Document:	Lighting Plan Review – Technical Note
Project:	Neilston Greener Grid Park Section 36 Application
Client:	TNEI (on behalf of Statkraft UK Ltd.)
Project Number:	784-B042549
File Origin:	\\lds-dc-vm-101\Data\Projects\784-B042549_Coylton__Neilston__Keith_BESS\60 Project Output\63 Published

This technical note summarises the appraisal of the external lighting design aimed at limiting the risk of adverse impacts to ecological receptors.

**APPENDIX A: EXTERNAL LIGHTING PLAN (REF: NGG-RPS-XX-XX-DR-E-6301 -
EXTERNAL LIGHTING – P10)**

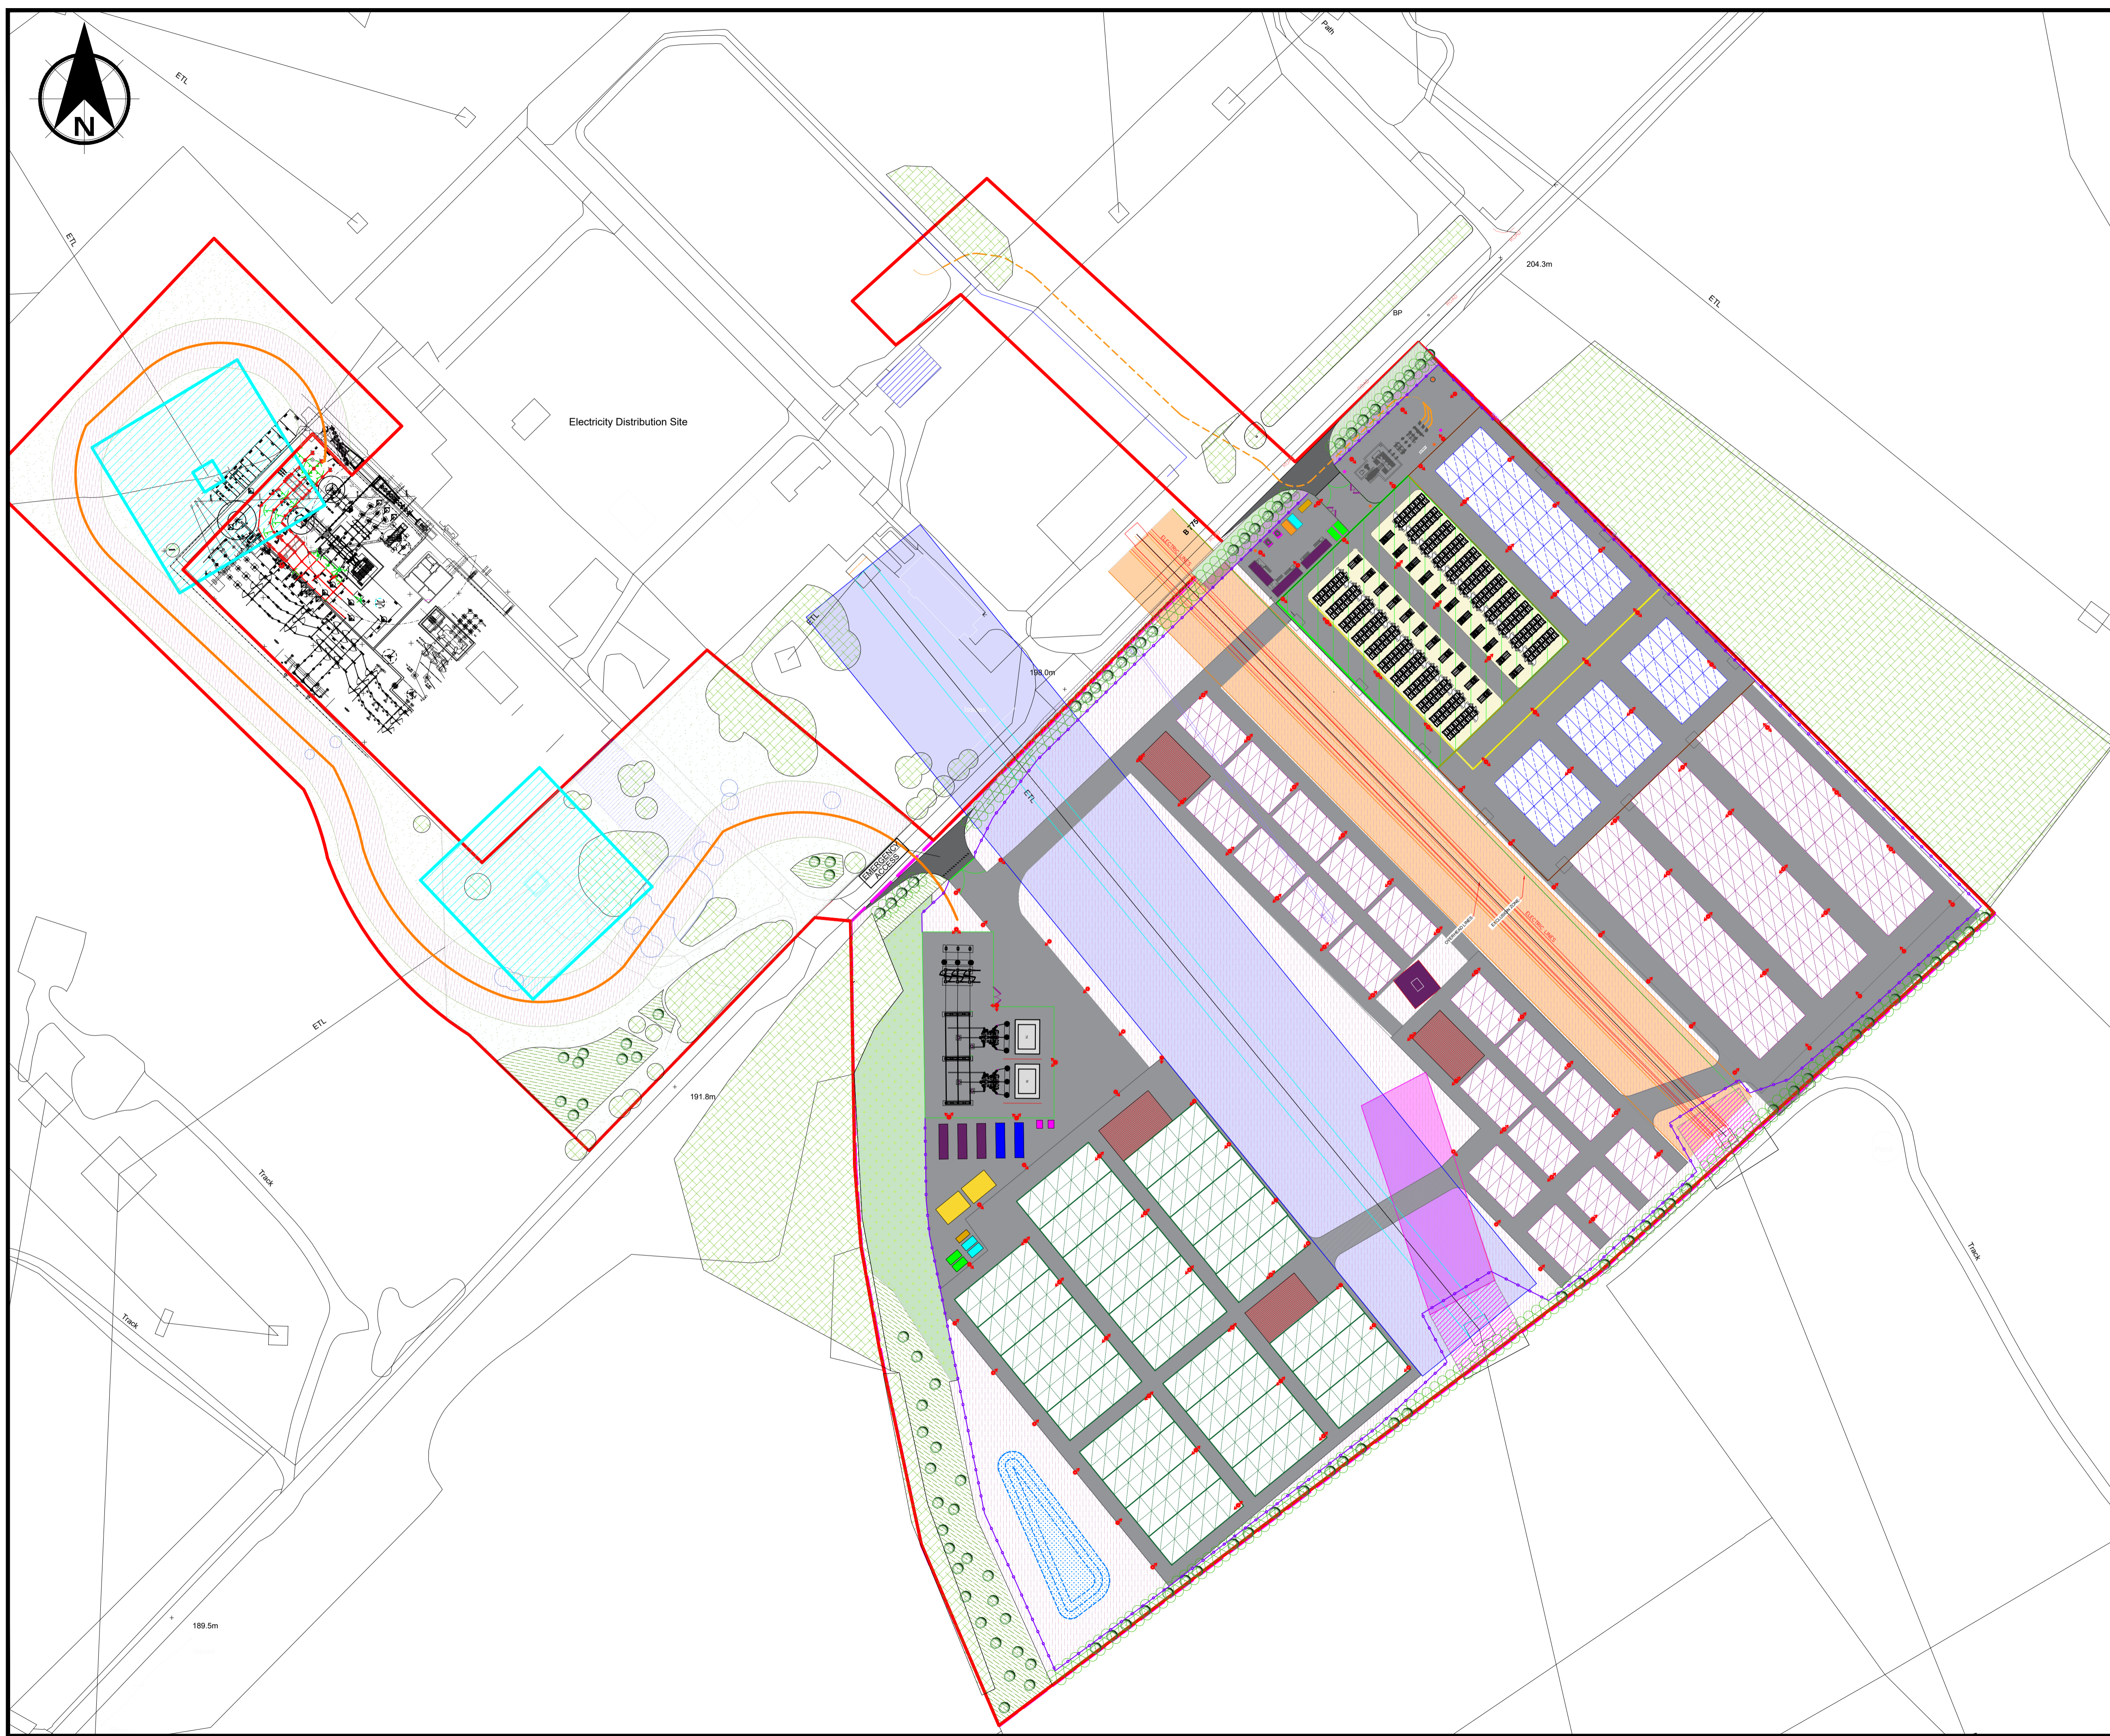
As per section 4.29 of the guidance, the luminaire specification as described above appears to be appropriate and compliant. Specifically, the luminaires will be LED and warm white (2700Kelvin), lacking metal halide or fluorescent sources, and will be primarily controlled by PIR sensors with an additional remote management system.

There is no physical screening of light spill. However, in compliance with the guidance, all luminaires are directed inward and are considered “forward throw”, which minimises light spill.

The lighting contours on the provided plan show that light spillage to the tree lines and vegetation adjacent to the site will be limited to 3 lux at between 0.5m and 1m from the site boundary in places, dropping to 1 lux at 2.5m from the site boundary.

Full moonlight often produces light levels in the region of 0.5-2 lux, and therefore this level of light spill is considered very low.

As the habitats surrounding the site are considered to be supporting rather than key habitats, are likely to be used by low numbers of bats, and the lighting for the site is likely to only occasionally be active, the lighting plan for the site appears to be appropriate and compliant with illuminance limits and buffers.

To ensure that lighting on the site is compliant with guidelines post-construction/during the operational phase, it is recommended that lighting surveys are conducted by a suitably qualified competent person on completion of installation. These surveys should ensure that the proposed lighting levels on the site have been achieved, that the specifications of the lighting are as proposed, and that the levels of light spillage are as expected.
